10/604,061

Group Art Unit: 3635

#### **REMARKS**

Fig. 3

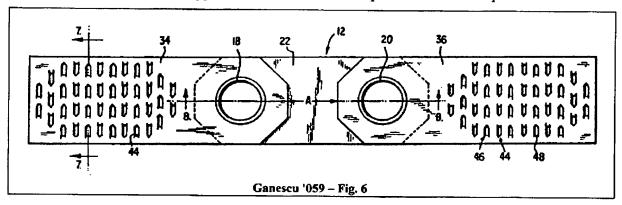
The Examiner has objected to the drawings as filed as not allegedly showing every feature of the invention specified in the claims. Specifically, the Examiner has asserted that the "the 'nail plate' must be shown or the feature(s) canceled from the claim(s)." This objection is respectively traversed.

A "nail plate" is a term of art in the lumber and lumber connector industry which refers to a plate having several teeth extending therefrom which can be hammered or press-fit into a piece of lumber board. The "nail plate" is clearly shown in detail in the drawings for this case in at least FIGS. 2-7 and 31-36 by teeth 66 (the series of teeth 66 on the hinge plate portions and the term "nail plate" can be used interchangeably):

In addition, the nail plate on the connector members of the hinge plate claimed in the invention is shown in use in at least FIGS. 8-23 and 37-67 (the patterned surface on the hinge plates shown in the drawings).

Thus, Applicant sees no need for corrected drawing sheets to be filed in compliance with 37 CFR 1.121(d) and, in addition, the Examiner's objection to the drawings should be withdrawn.
